Process Sheet

Customer	: CC-DAR01 Dart Aerospace Ltd.		Drawing Name	: G10608-1	
Job Number	: 35387		Part Number	: D3637041	
Estimate Number	: 10804		Drawing Number	: RE-IDENTIFY	
P.O. Number	: N/A		Project Number	: N/A	
This Issue	: 14/11/2007	S.O. No. : N/A	Drawing Revision	: N/A	
Prsht Rev.	: NC		Material	: N/A	
First Issue	: 25/10/2007	Type : SMALL /MED FAB	Due Date	: 01/11/2007 Qty: 11 Um: Each	
Previous Run	: 35384				
Written By	:				
Checked & Approved By	:				
Comment	:

D3637-041 BRACKET ASSEMBLY
(WAS GENEVA P/N G10602-1)

From: Leanne Elsliger [leelsliger@dartaero.com]
Sent: November 5, 2007 4:20 PM
To: 'Linda Lacelle'
Subject: D3637-1

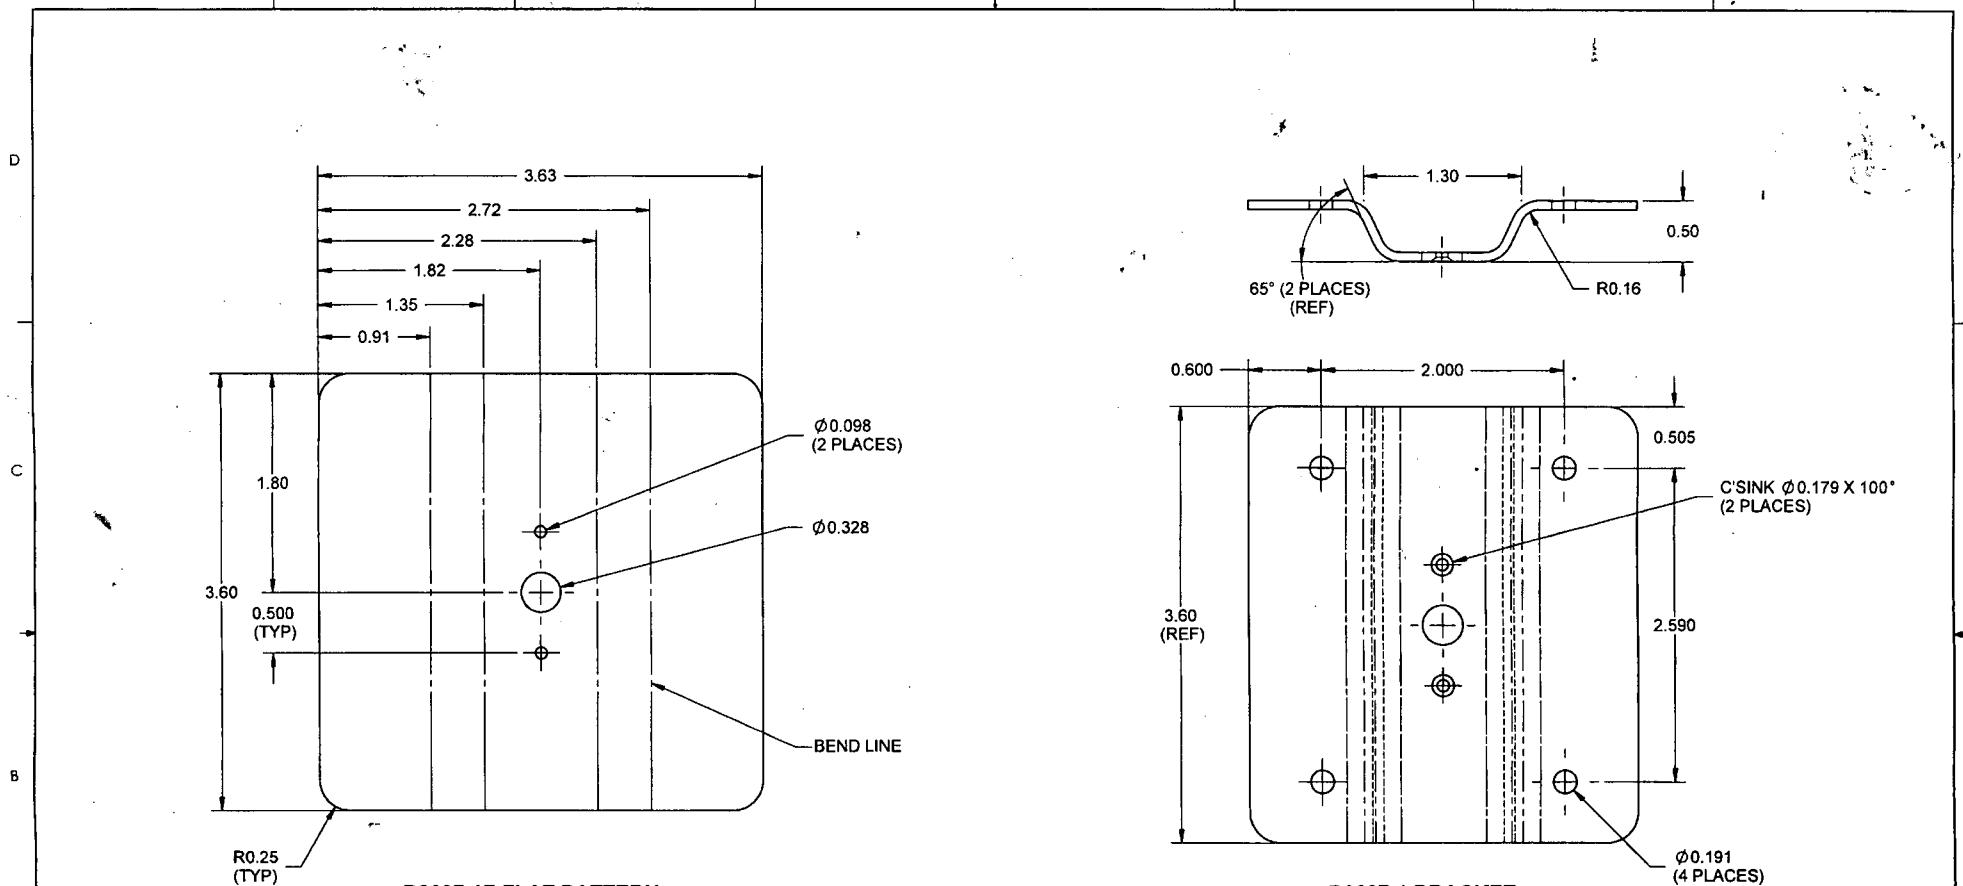
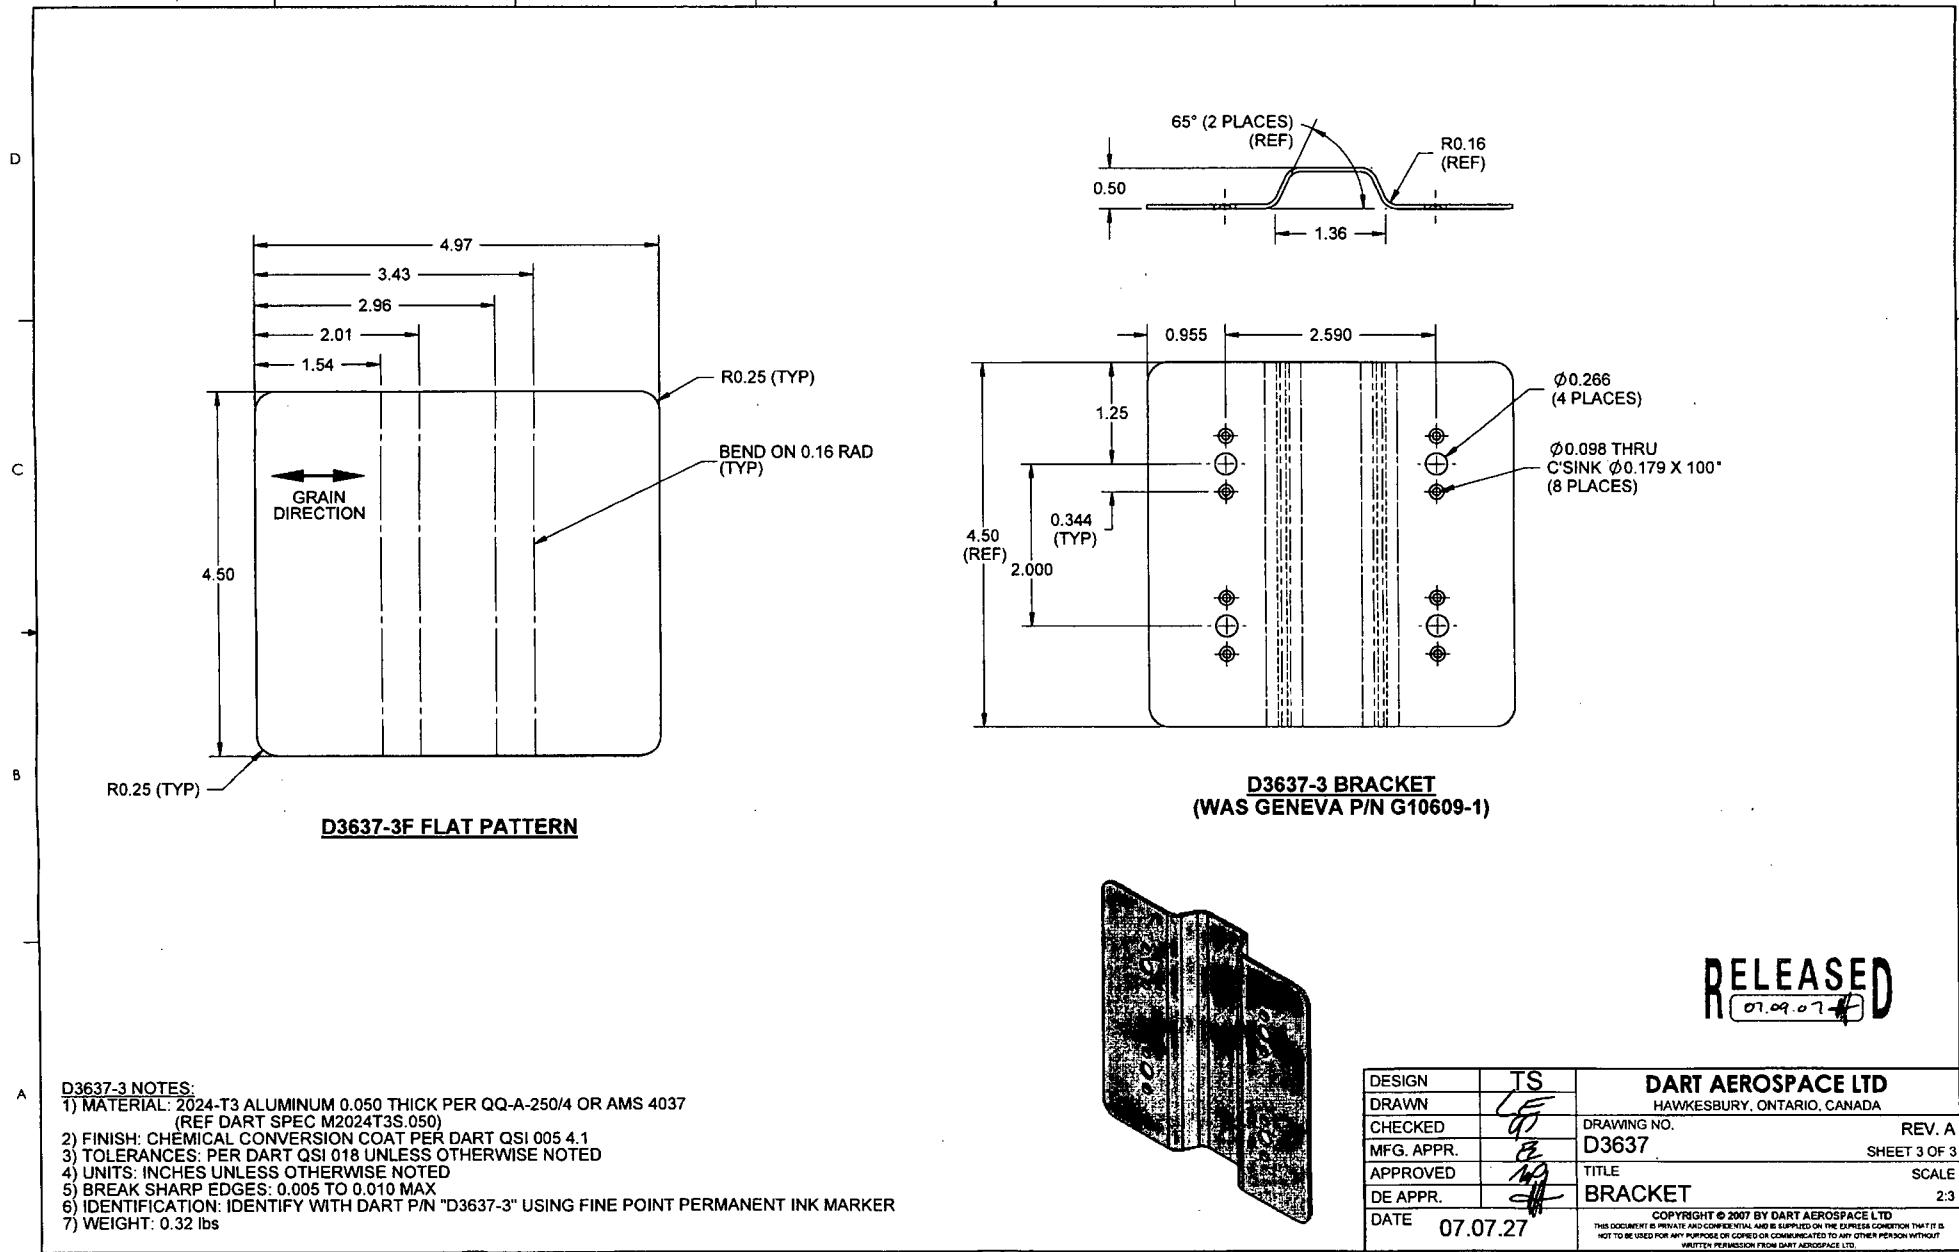
Linda – the Geneva p/n G10608-1 that we gave Dart p/n D3637-1 has two countersinks that we do not have on our part. I forgot about these until Eric D brought them to my attention (sorry). There are 11 of them. You can either scrap them or rework the parts by welding.

Seq. #:	Machine Or Operation:	Description :
1.0	PACKAGING 1	PACKAGING RESOURCE #1 Comment: PACKAGING RESOURCE #1
2.0	LARGE FAB 1	LARGE FABRICATION RESOURCE 1 Comment: LARGE FABRICATION RESOURCE 1 <i>316 SS. ROD 1 B m/104721</i> <i>weld over countersinks</i> <i>surf. grind smooth</i> <i>FC 07/11/19 ⑪</i>
3.0	QC9	VISUAL WELDING INSPECTION Comment: VISUAL WELDING INSPECTION <i>⑪ 07-11-19 ⑪</i>
4.0	SMALL FAB 1	SMALL & MEDIUM FAB RESOURCE 1 Comment: SMALL & MEDIUM FAB RESOURCE 1 <i>INSTALL NUTPLATE PER DRWG D3637 REV.A</i> <i>ml 07/11/20 x 11</i>
5.0	G106081	Bracket Comment: Qty: 1.0000 Each(s)/Unit Total: 11.0000 Each(s) <i>Doubler</i>

NCR:		WORK ORDER NON-CONFORMANCE (NCR)						
DATE	STEP	Description of NC Section A	Corrective Action Section B			Verification Section C	Approval Chief Eng	Approval QC Inspector
			Initial Chief Eng	Action Description Chief Eng	Sign & Date			
07/11/20	4	C sink not deep enough. Bad install of rivets.	081042	took out 2 rivets and nut plate, Re-do C sink. Replace 2 rivets ms20427AD and 1 nutplate ms21059L4 m102959	07/11/20	081042	081042	081042
